S E R V I C E N O T E

SUPERSEDES: 8751A-22

8751A Network Analyzer

Modification prevents the 8751A from hanging up or generating an unexpected reset**To Be Performed By:** Agilent-Qualified Personnel**Parts Required:**

Figure 1. A1 Board Parts Location

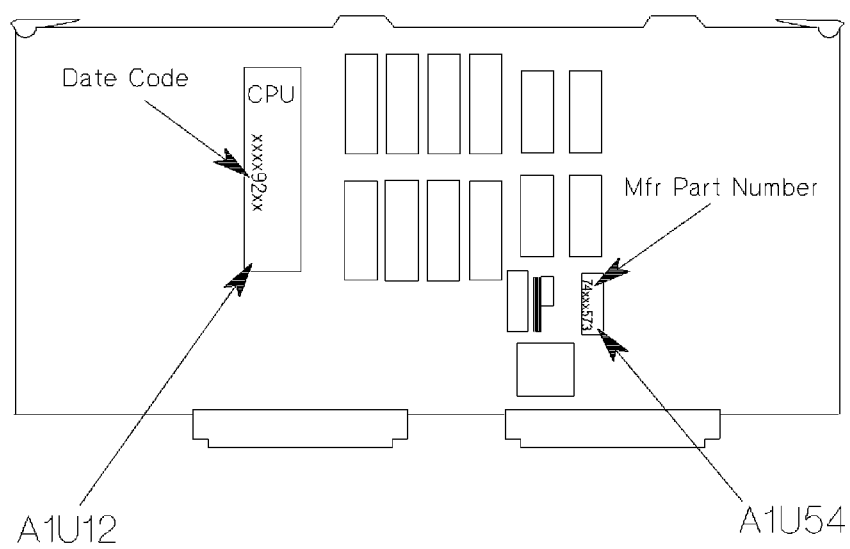
If the Date Code of the A1U12 is "92xx" and the Mfr Part Number of the A1U54 is "74F573" or "74BCT573", the address error may occur, which hangs up the 8751A or generates an unexpected reset.

1. Disconnect the power cable from the 8751A.
2. Remove the top cover and the shield plate from the 8751A.
3. Remove the A1 board from the 8751A.
4. Check the Date Code of the A1U12 and the Mfr Part Number of the A1U54.
(The Date Code and the Mfr Part Number are printed on each part. See Figure 1.)

If the Date Code of the A1U12 is “92xx” and the Mfr Part Number of the A1U54 is “74F573” or “74BCT573”, proceed to the next step.

Replace the A1U54 with the new one (Mfr Part Number: 74ABT573, Part Number: 1820-8885).

5. Remove the old A1U54 (Mfr Part Number: 74F573 or 74BCT573).

6. Install the new A1U54 (Mfr Part Number: 74ABT573, Part Number 1820-8885)
7. Reinstall the A1 board in the 8751A.
8. Turn the 8751A ON and confirm the “POWER ON TEST FAILED” message is NOT displayed.
9. Turn the 8751A OFF.
10. Reinstall the shield plate and the top cover on the 8751A.
